RE: Comments on the Eastern Tule GSA draft Groundwater Sustainability Plan

**Re: Comments on the Eastern Tule Groundwater Sustainability Plan**  
**DRAFT**

Re: Comments on the Draft Groundwater Sustainability Plan for the Eastern  
Tule Groundwater Sustainability Agency

Re: Evaluation of Eastern Tule Subbasin Draft Groundwater Sustainability Plan

**Figure 1 - Representative Monitoring Network for GW Levels Relative to Domestic Wells, DACs, and Community Water Systems Eastern Tule GSA**

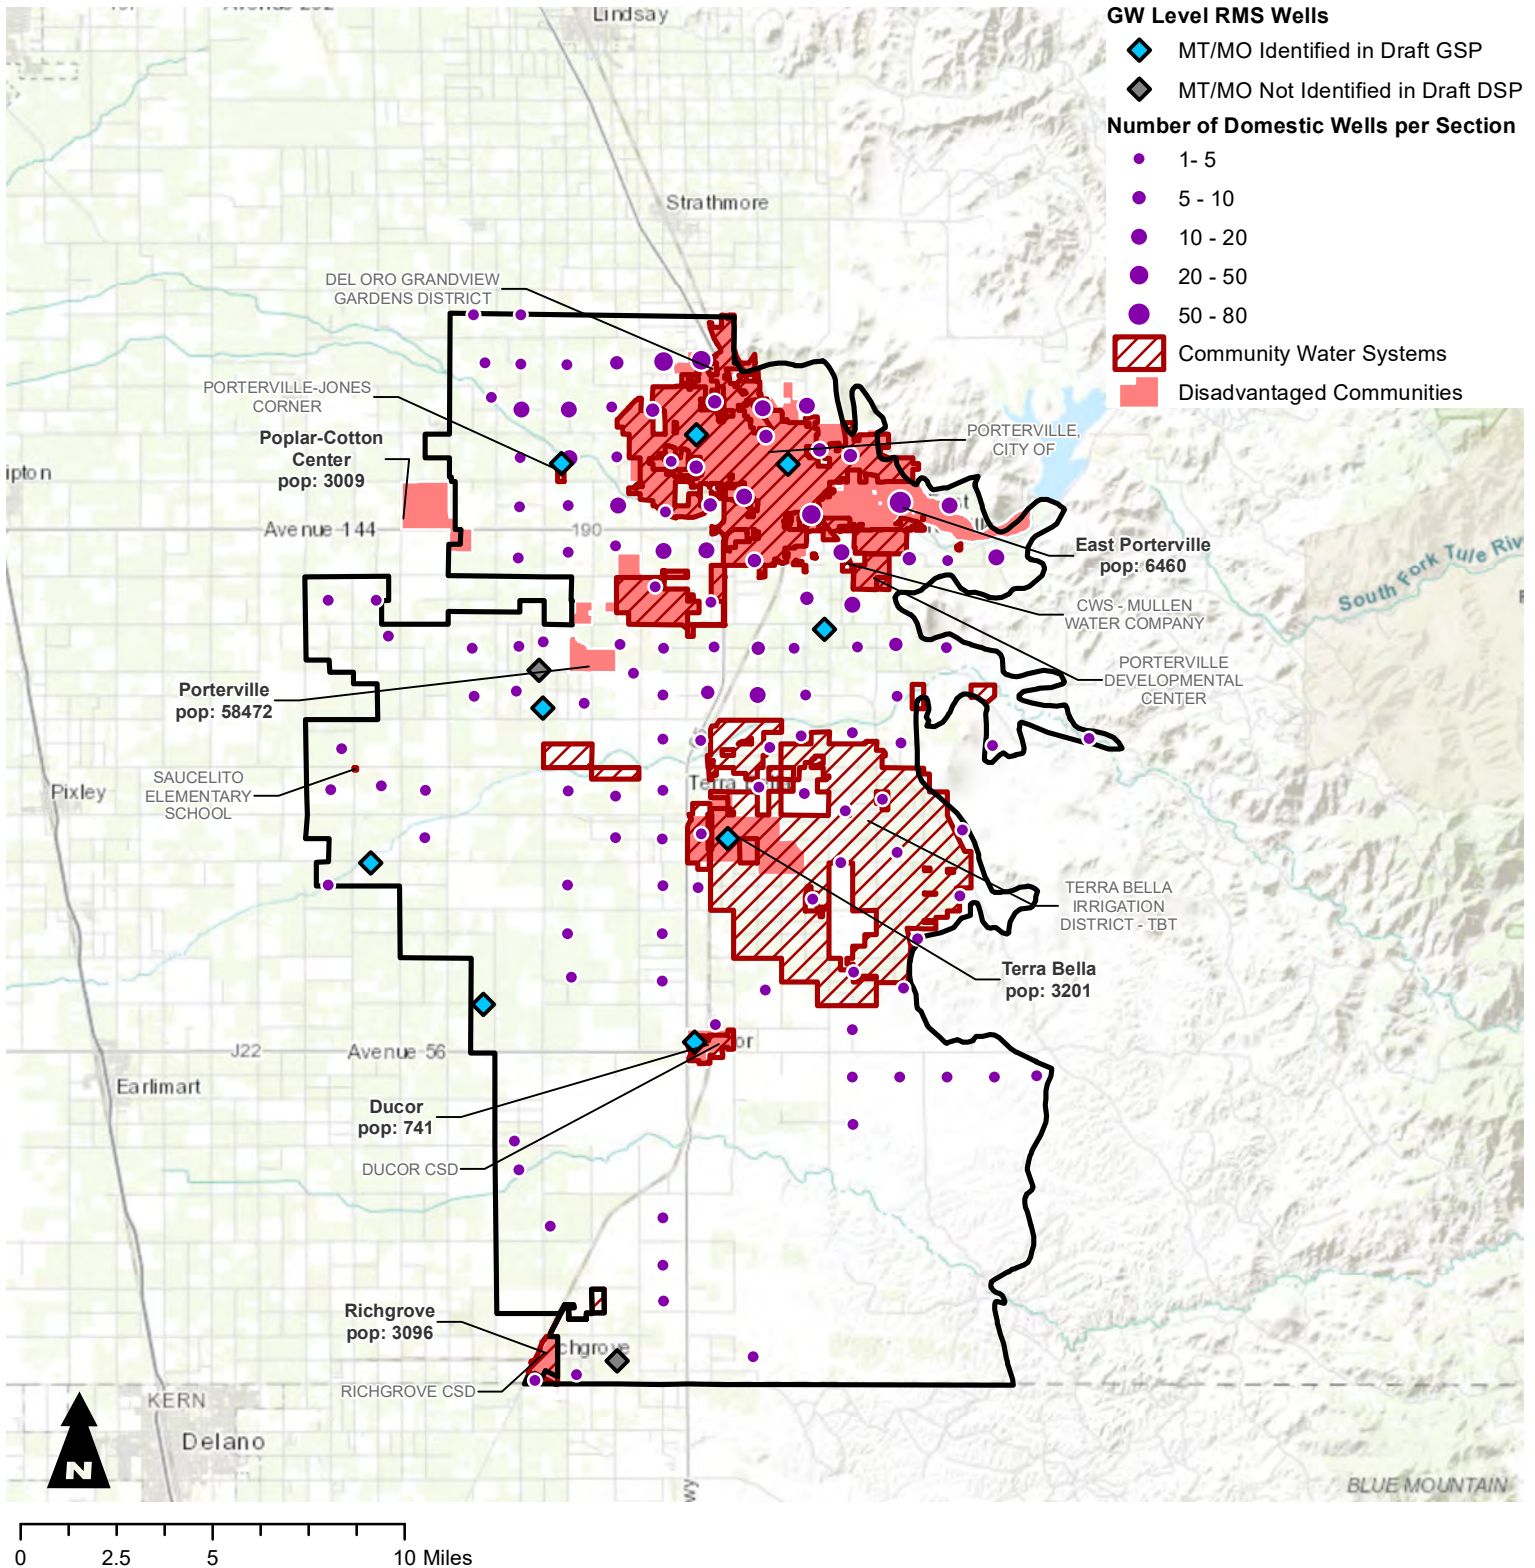
- Notes**
1. All locations are approximate.
  2. Two wells are marked as RMS in the Tule Subbasin Monitoring Plan but are not identified in the draft GSP with MO/MT values.

RMS wells in Figure 5-1 from the draft GSP are not used due to information discrepancy with Table 5-8. Two RMS wells are identified in Table 5-8 but could not be located due to missing well information in the draft GSP.

**Figure 2A - Estimated Water Level Decline at Measurable Objectives and Domestic Wells  
Eastern Tule GSA**

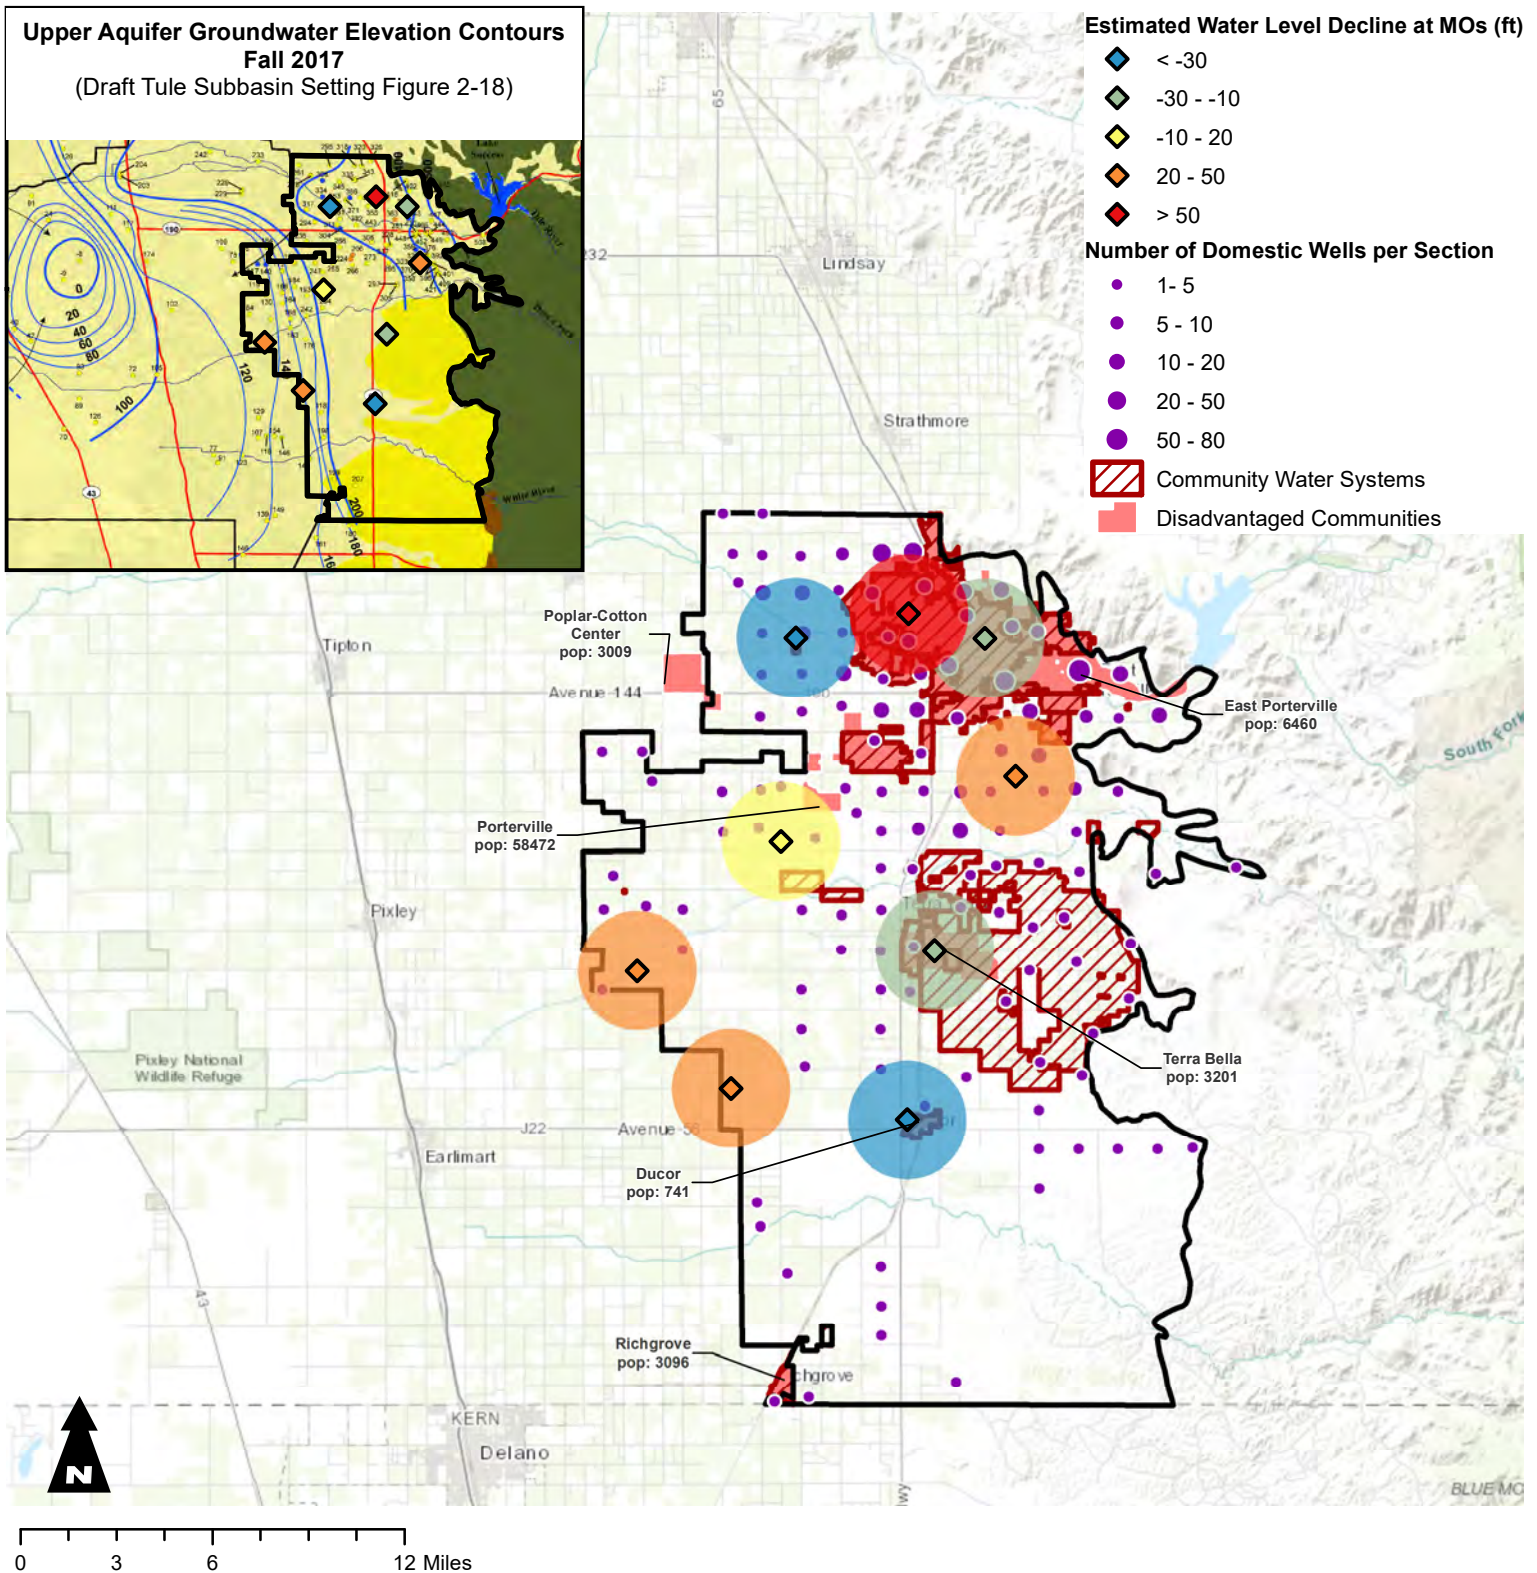
1. CWC Figure 1— Representative Monitoring Network for GW Levels Relative to Domestic Wells, DACs, and Community Water Systems
2. CWC Figure 2A - Estimated Water Level Decline at Measurable Objectives and Domestic Wells
3. CWC Figure 2B - Estimated Water Level Decline at Minimum Thresholds and Domestic Wells
4. CWC Figure 3 - Water Level Minimum Thresholds and Domestic Wells
5. CWC Figure 4 - Representative Monitoring Network for GW Quality Relative to Domestic Wells, DACs, and Community Water Systems
